Staff Report & Recommendation

Design Review Board

SUBJECT: Design Review File No. 23204
31 Venetian Way

The applicant, **Euroamerican Group Inc.**, is requesting Design Review Approval for the construction of a new five-story multifamily building which will replace four (4) existing three-story buildings, including a variance to reduce the required side setback for a driveway.

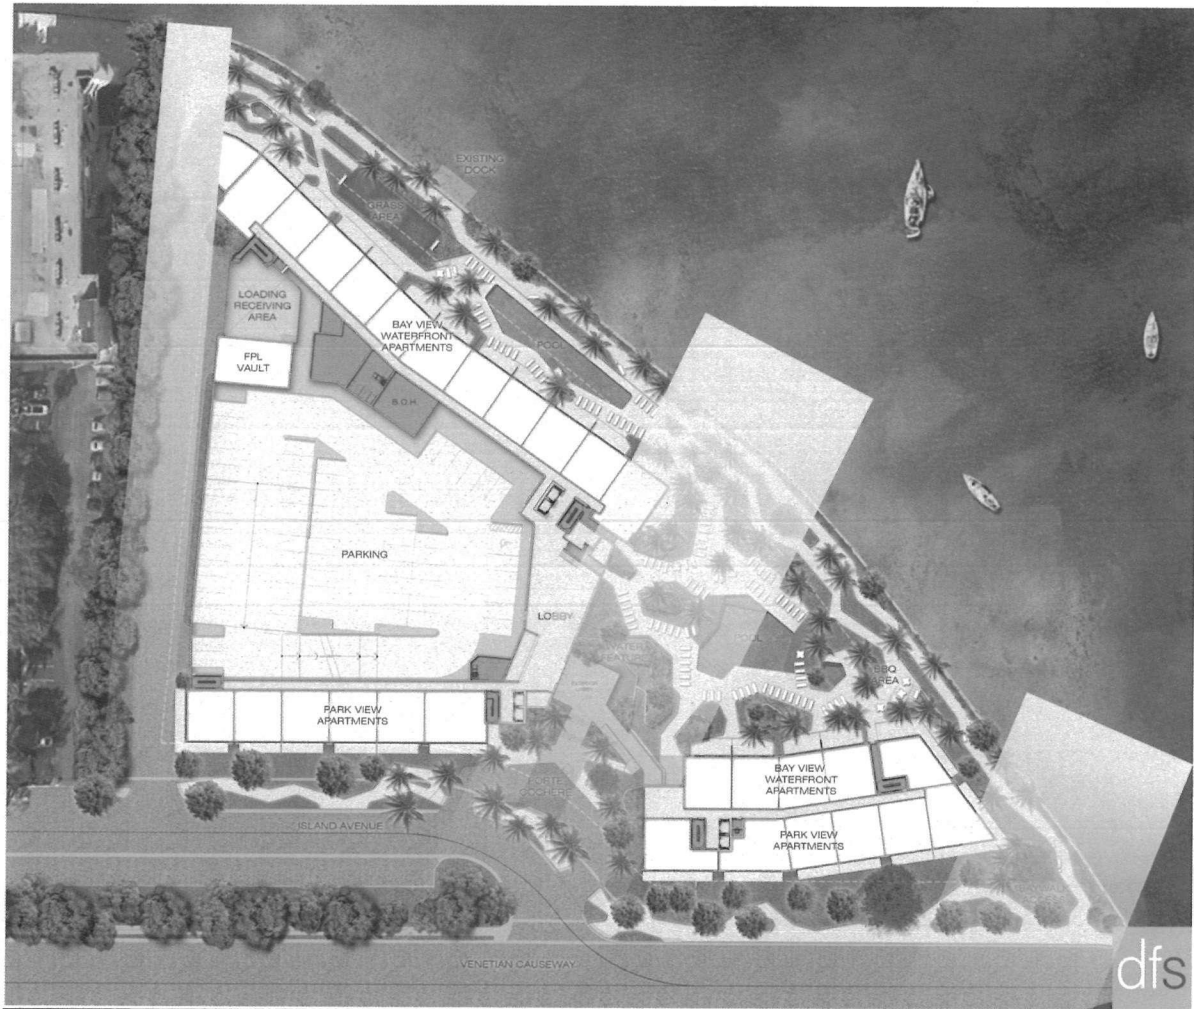
However, the proposed separation is still not sufficient as a true unimpeded view corridor, as there are many architectural and landscape obstacles within the opening that effectively block

the view corridor. Also, although the applicant has provided a continuous Public Baywalk, a pedestrian connection has not been provided at the western portion of the site.

In order to be consistent with the established scale, character and context of the north side of Belle Isle, as well as to create a true view corridor, which is the intent of the Design Review criteria herein, staff would recommend that the applicant further separate the southeastern wing of the building to a minimum unimpeded width of 100'-0". This number is calculated using Section 33D-38(2) of the Code of Miami-Dade County pertaining for shoreline reviews: "an unimpeded visual corridor to Biscayne Bay of 20% of the width of the lot". Based on the total shoreline length of approximately 750'-0", a 100'-0" unimpeded viewing corridor is required. These areas should be maintained free of constructions or landscape obstructions. Further, the elimination of the lobby central portion and the units covering the potential view corridor opening at the top level is recommended—this would leave the area open to sky with the exception of a single story trellis of covered breezeway to connect the two buildings. Additionally, the one-story porte-cochere may remain. This change is also consistent with the previously approved site plan at the subject property.

- Expand the unimpeded width of the central view corridor, to a minimum of 100'-0". This can be accomplished by relocating the corner line of units on each building.

- The central and eastern view corridors shall incorporate the following: be open to the sky, at a 45 degree angle or less (from Island Avenue), be at an elevation that is no greater than adjusted grade, and not contain any parking, accessory or ancillary structures.
